BULLETIN NO. 33

JEFFERSON LAB

TECHNICAL ENGINEERING & DEVELOPMENT FACILITY
(TEDF TWO)

Bulletin No.33
Project No. 20080400
March 04, 2011

4 SECTION DETAIL
3" = 1'-0"

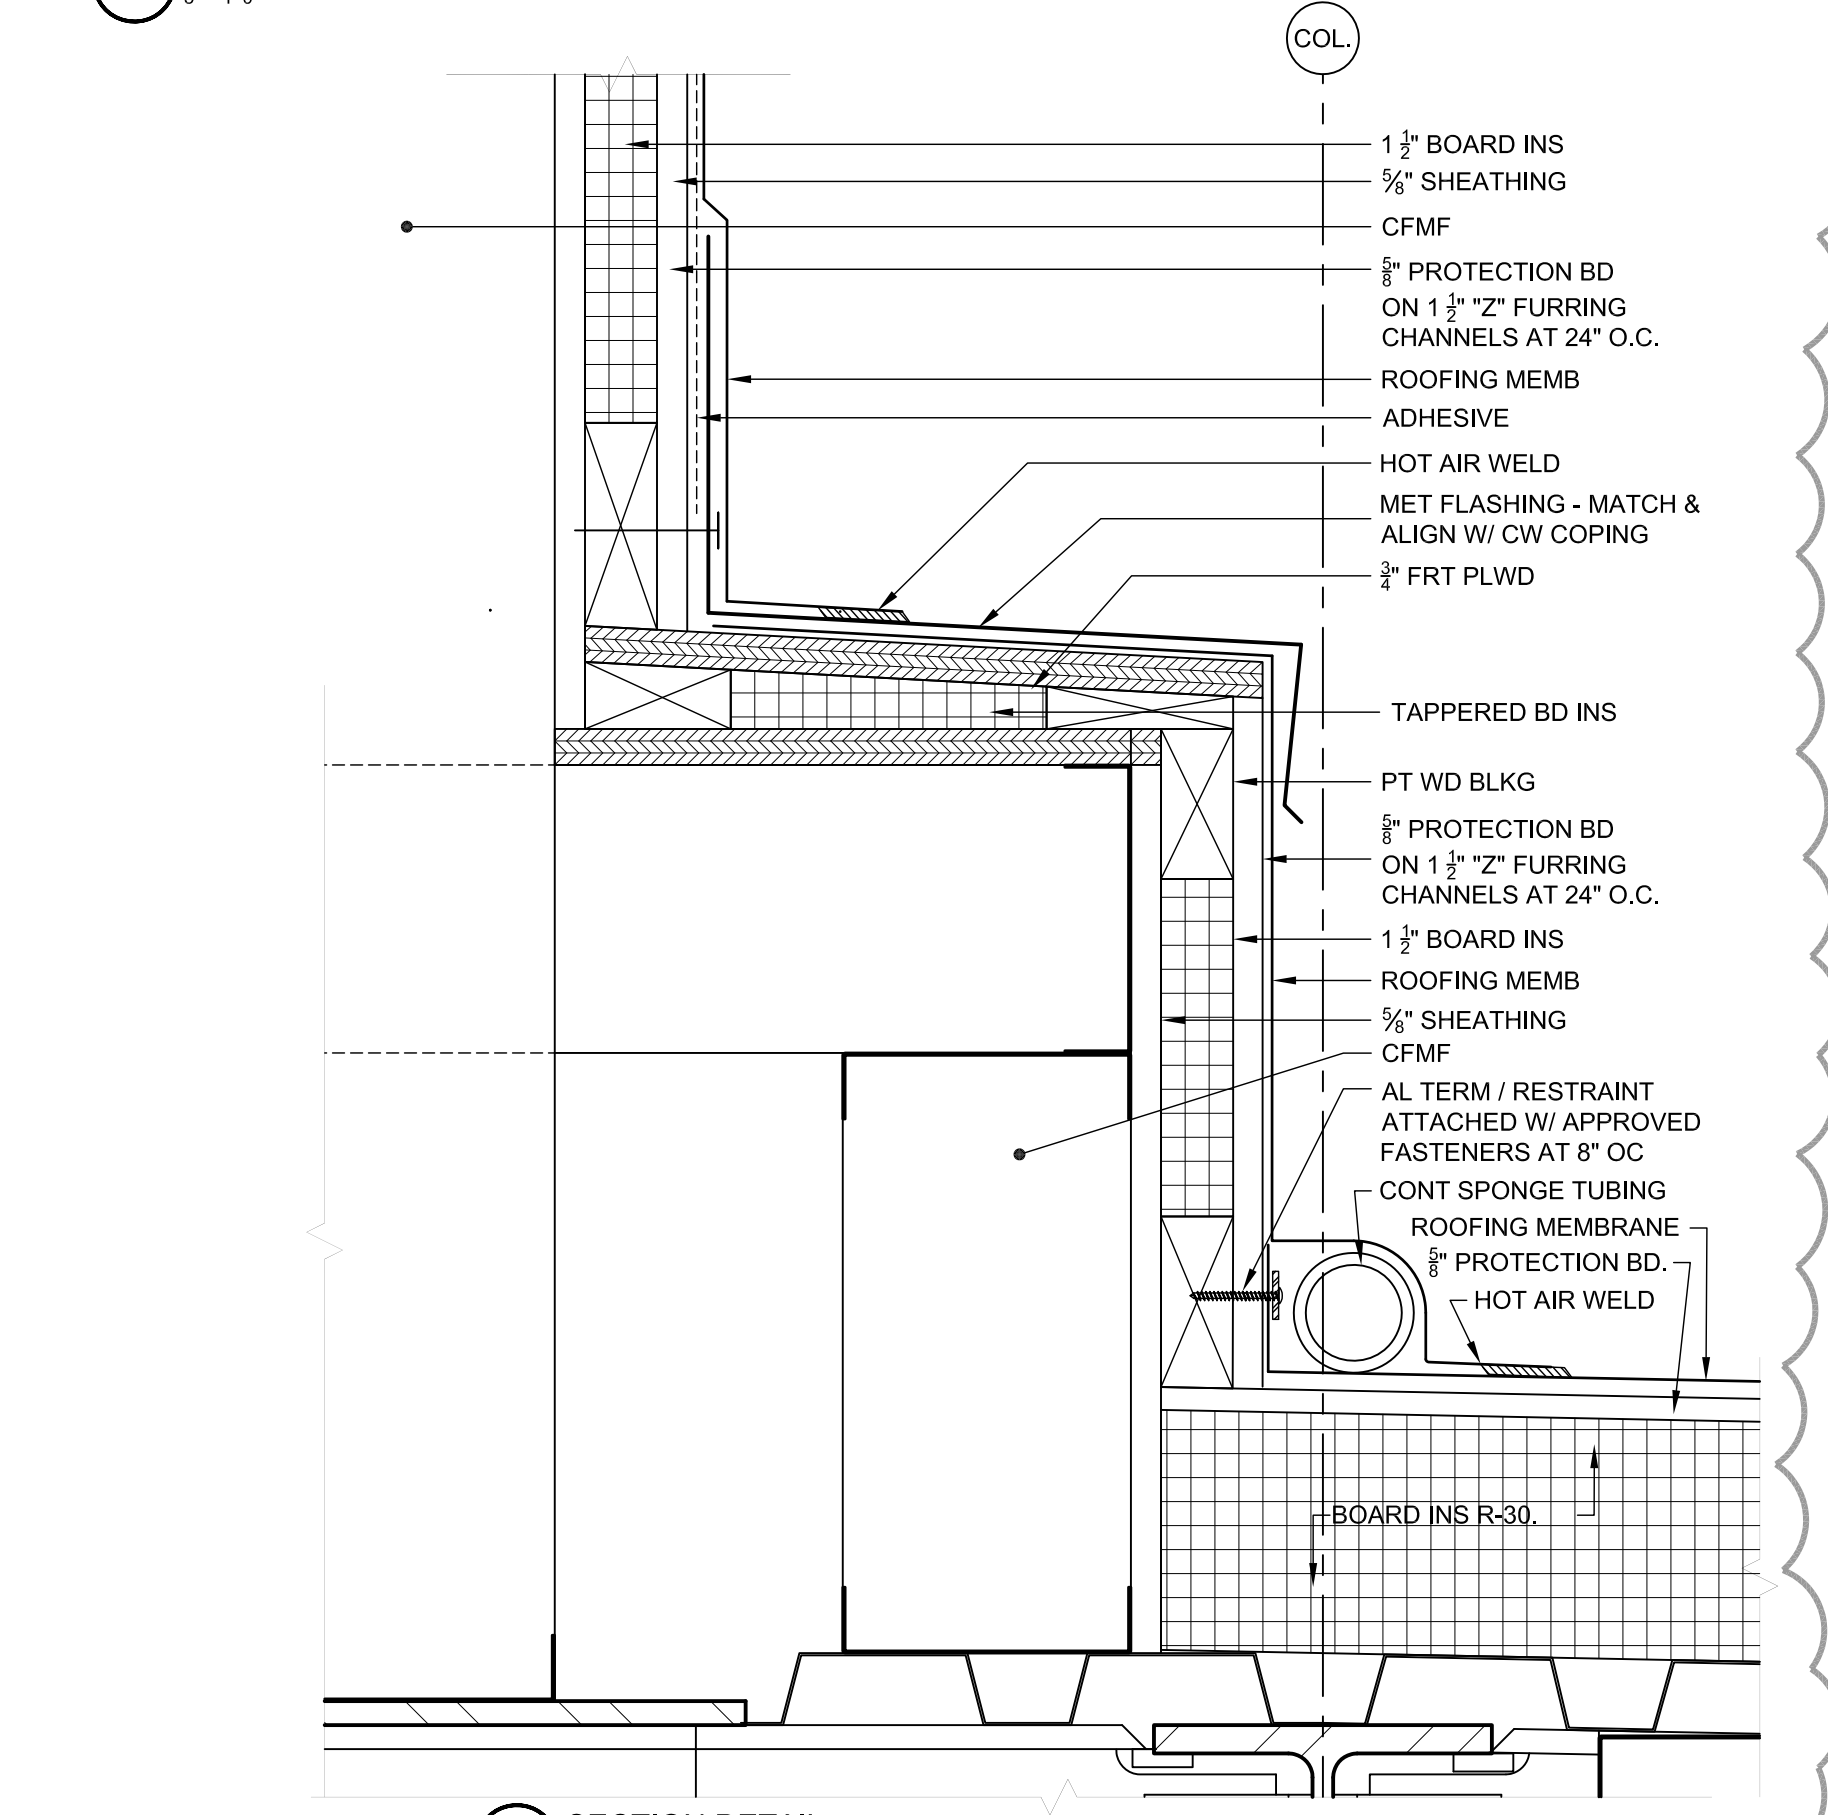
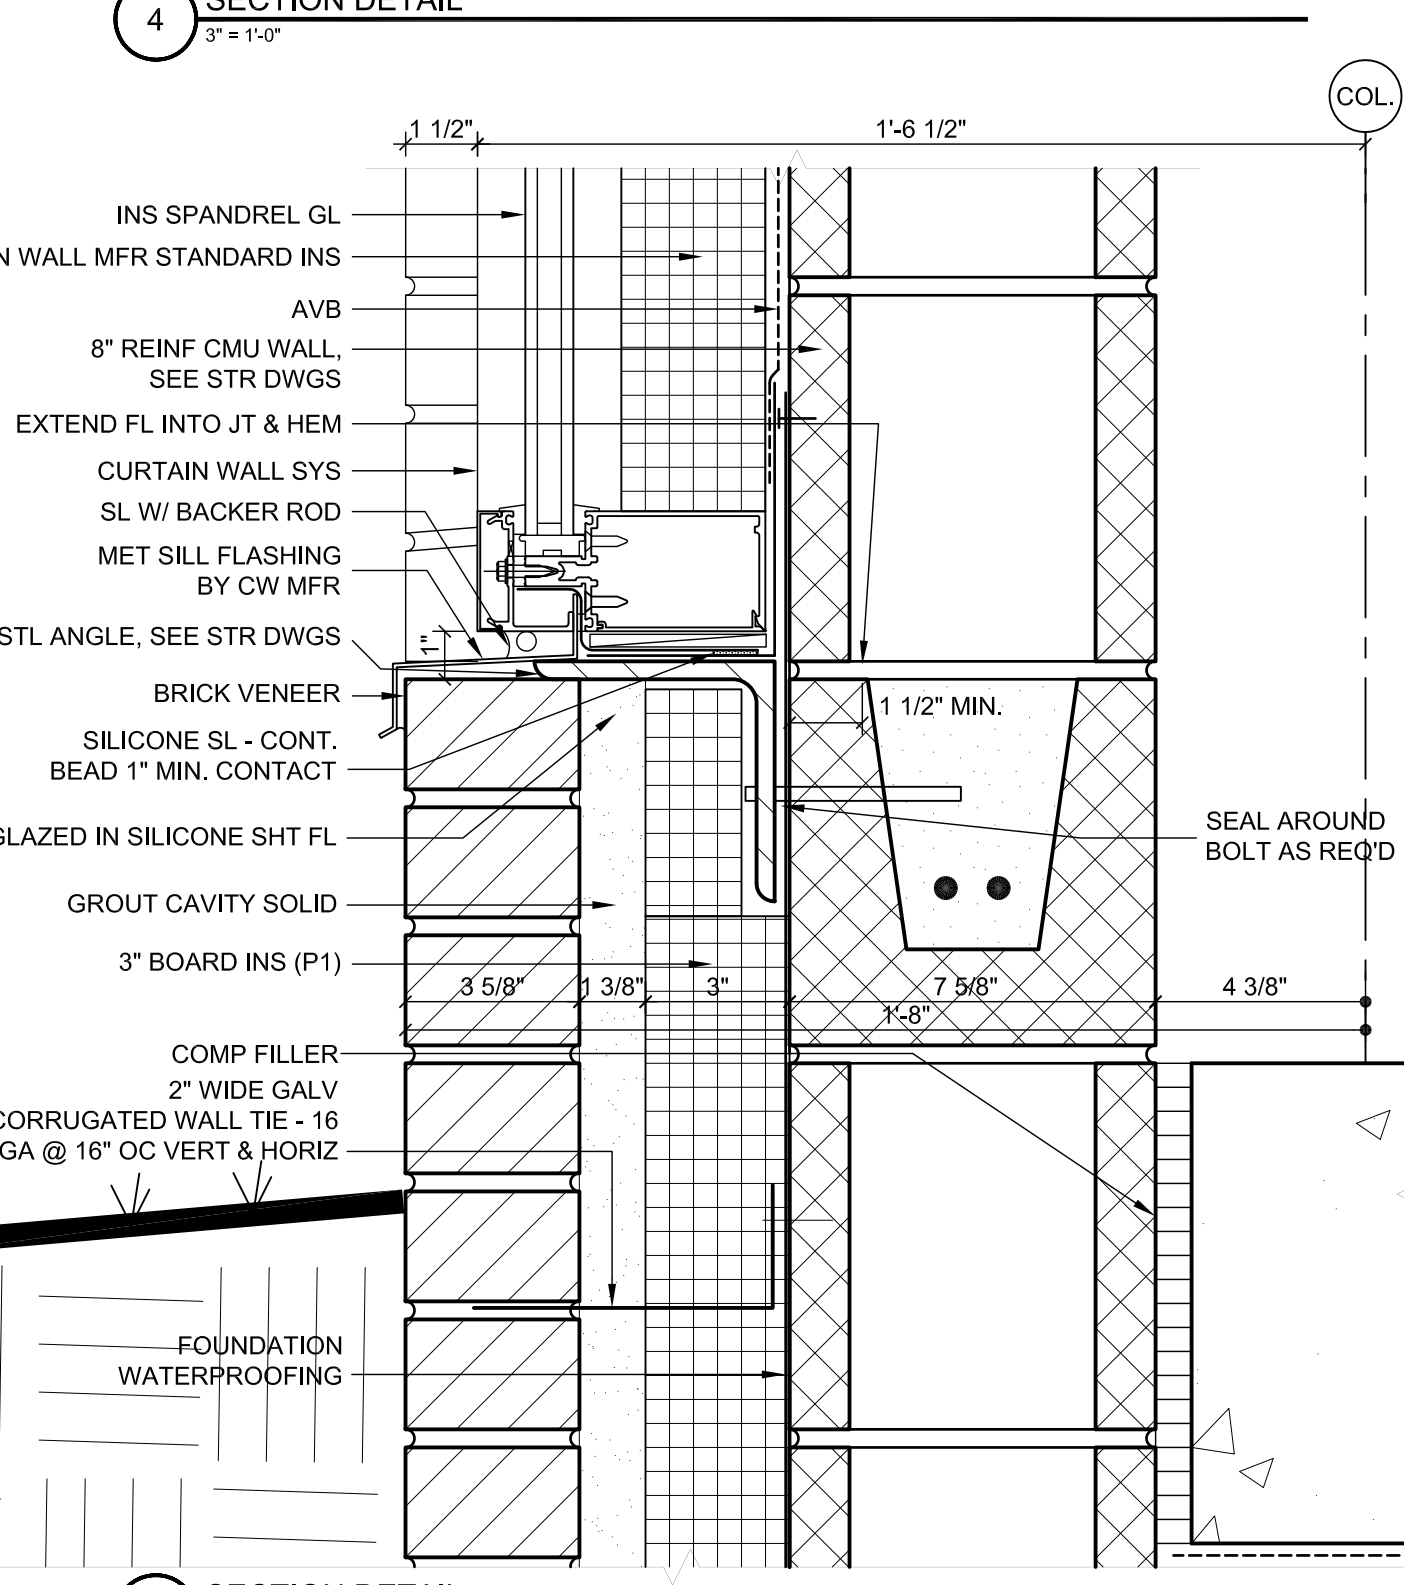
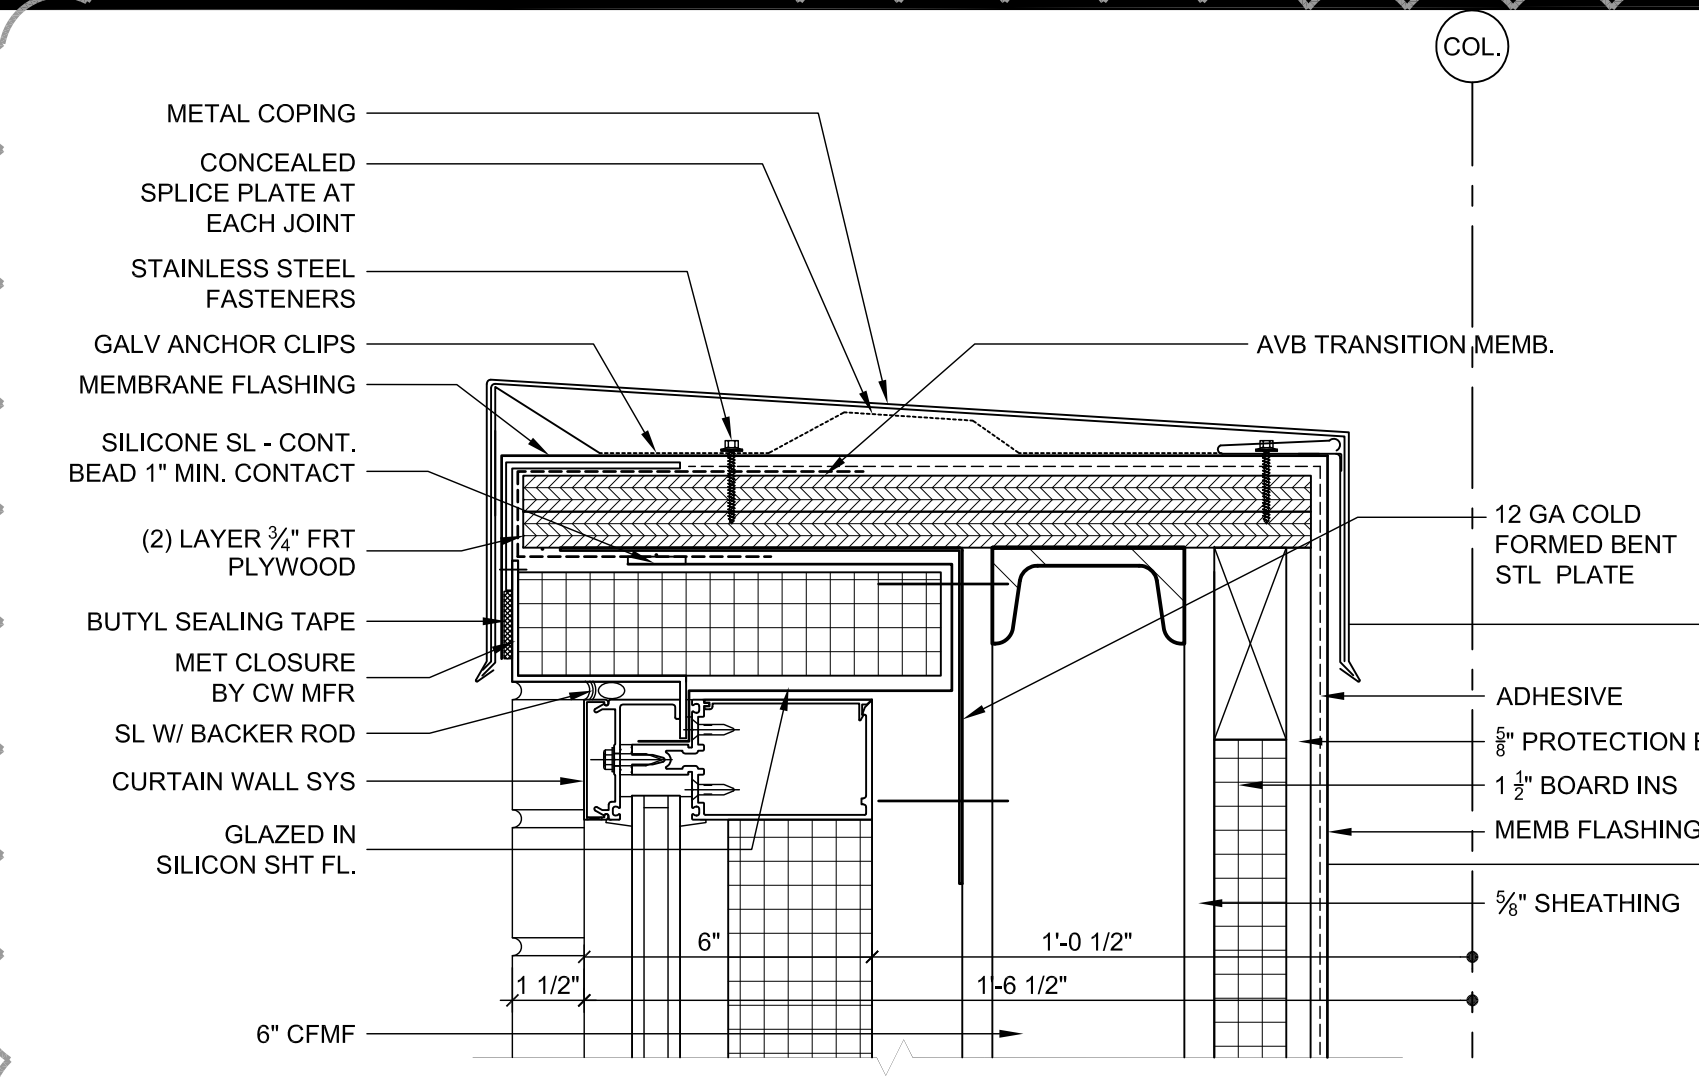
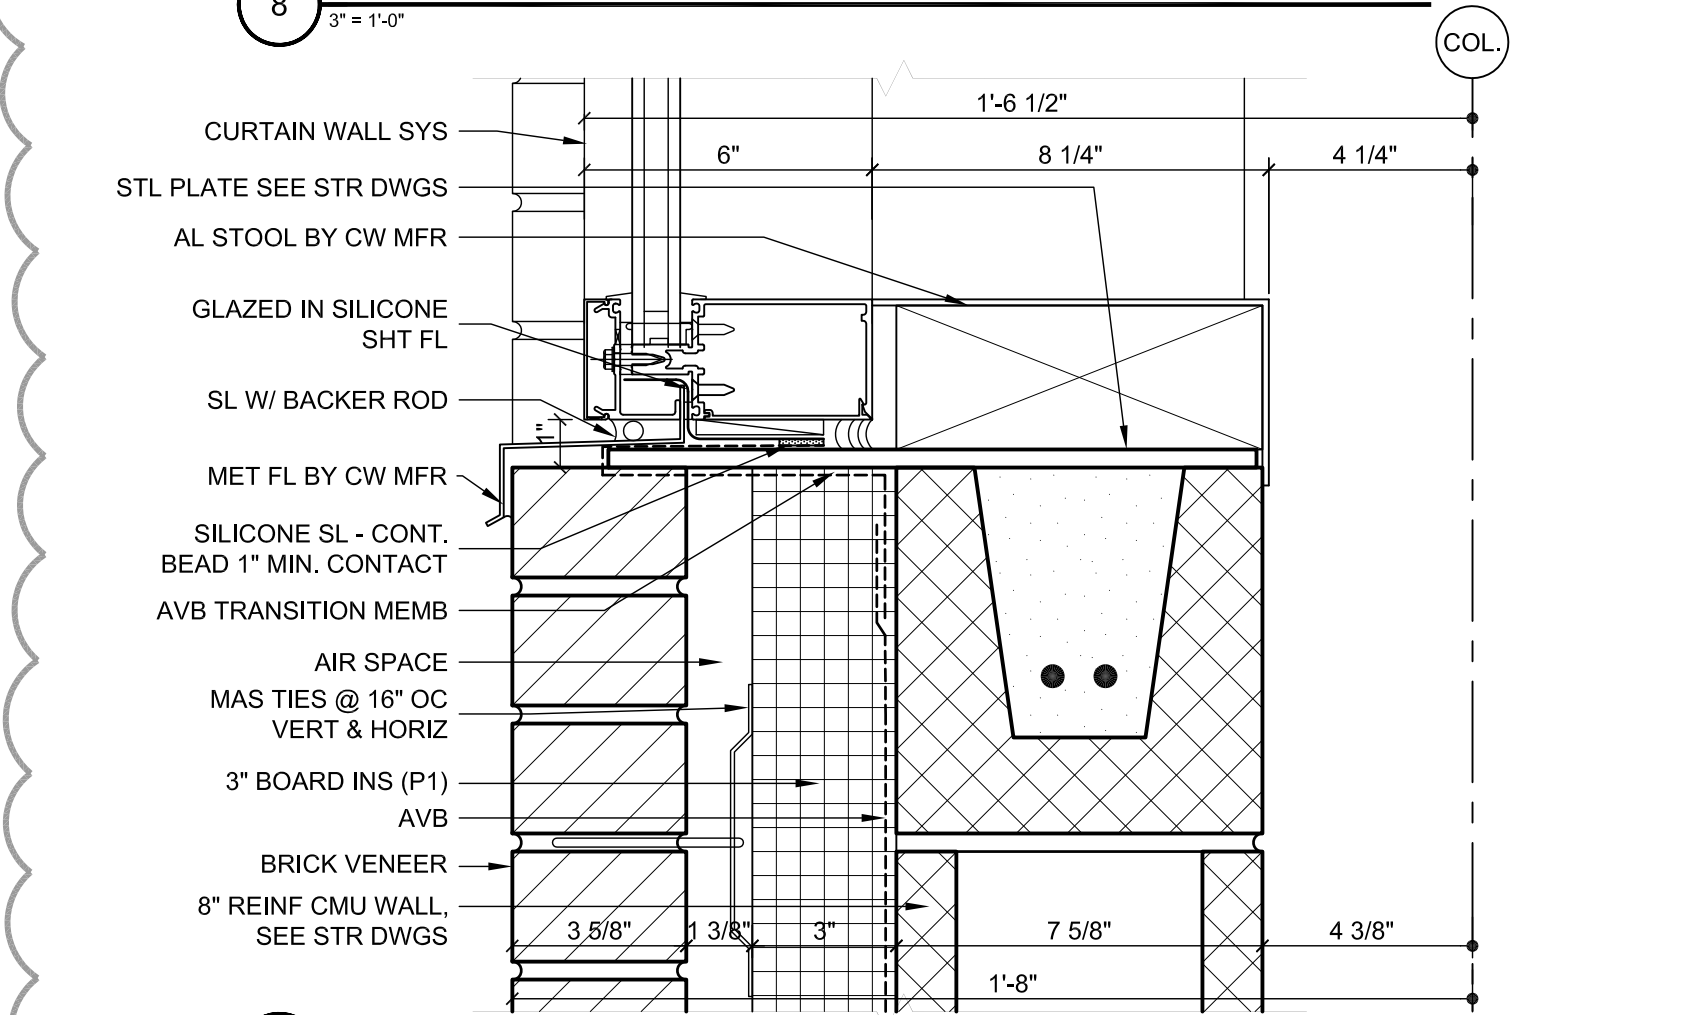
1. Revised section details
